**PLANNED UNIT DEVELOPMENT
& SUBDIVISION STAFF REPORT****Date: August 17, 2006****LOCATION**

West Hill Subdivision

West terminus of Hilltop Drive South

APPLICATION NUMBER 26 & 27 DATE August 17, 2006
APPLICANT West Hill Subdivision
REQUEST Subdivision, Planned Unit Development

TYPICAL LOT LAYOUT

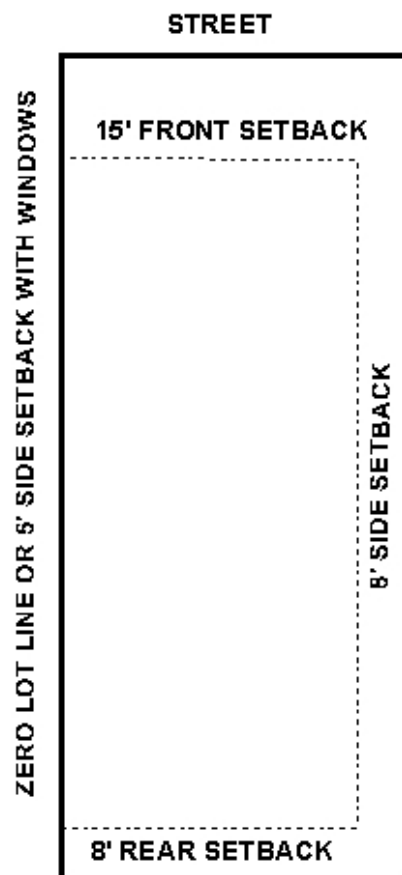
The plat shows a 15-foot front yard setback, and standard 8-foot rear setbacks. Eight of the 11 lots are illustrated with zero-lot lines on one side and 8-foot setbacks on the other. Five are less than the 60 feet wide typically required, with between 50 and 57 feet at the building setback line. The final plat should scale the setbacks shown, as some appear to be less than 8 feet. In addition, due to the number of easements that would supersede the reduced setbacks, the enlarged depictions of the lots should read "Typical Setbacks, Lots 1-5" and "Typical Setbacks, Lots 8-11", rather than seeming to absolutely depict the setbacks for those lots.

Subdivision: The plat meets the minimum requirements of the Subdivision Regulations and is recommended for Tentative Approval subject to the following conditions: 1) compliance with Engineering comments (Must confirm adequate storm water detention is available for increase in site coverage. Must comply with all storm water and flood control ordinances. Any work performed in the right of way will require a right of way permit. The applicant is responsible for verifying if the site contains wetlands. The site can be checked against the National Wetlands Inventory (NWI) on the COM web site Environmental Viewer. If the site is included on the NWI, it is the applicant's responsibility to confirm or deny the existence of regulatory wetlands.); 2) compliance with Urban Forestry comments (Property to be developed in compliance with state and local laws that pertain to tree preservation and protection on both city and private properties (State Act 61-929 and City Code Chapters 57 and 64). Preservation status is to be given to the 55" Live Oak Tree located on the South side of Lot 1. Any work on or under this tree is to be permitted and coordinated with Urban Forestry; removal to be permitted only in the case of disease or impending danger.); 3) construction and dedication of the new street to City Engineering standards; 4) revision of the final plat to show direct access to the common detention area from the street; 4) placement of a note on the final plat stating the approved maximum site coverage for each lot in percentage and square feet; 5) that the setbacks be scaled on the final plat, and that the enlarged depictions be described as "typical setbacks"; and 6) provision of a revised PUD site plan to Urban Development prior to signing the final plat.
